Addendum No. 1

Subject: J. H. BROWN ELEMENTARY SCHOOL
CLASSROOM MODERNIZATION
SDP CONTRACT NOS. B-037 C, B-039 C

Location: J. H. BROWN ELEMENTARY SCHOOL
3600 STANWOOD STREET
Philadelphia, PA 19136

This Addendum, ***dated 9th of May 2018***, shall modify and become part of the Contract Documents for the work of this project. Any items not mentioned herein, or affected by, shall be performed strictly in accordance with the original documents.

Ceiling Speaker Grille Assemblies

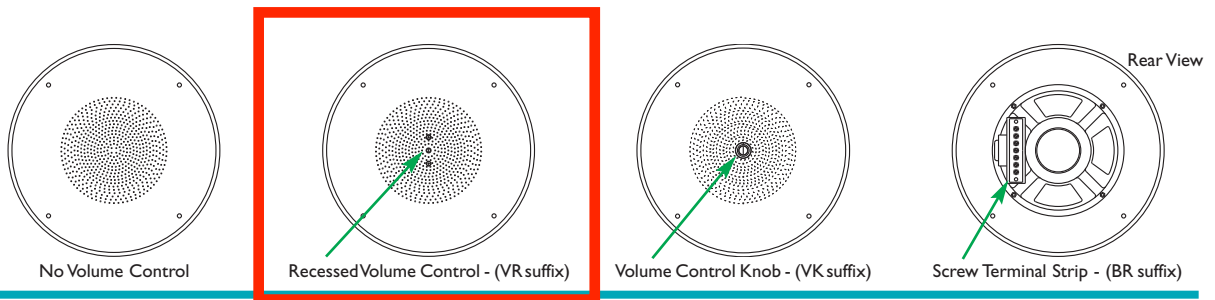
- .13 Question:** The demolition drawings say to replace ceiling speakers and wall telephones if they are not functioning. What is the manufacturer/model the owner wants for these (2) pieces of equipment as no spec was provided?

* Ceiling speaker will need ceiling mounting bracket*

Response: EC shall provide speakers, see attached cut sheet for ceiling speaker. SDP will furnish new telephone handsets for installation by EC.
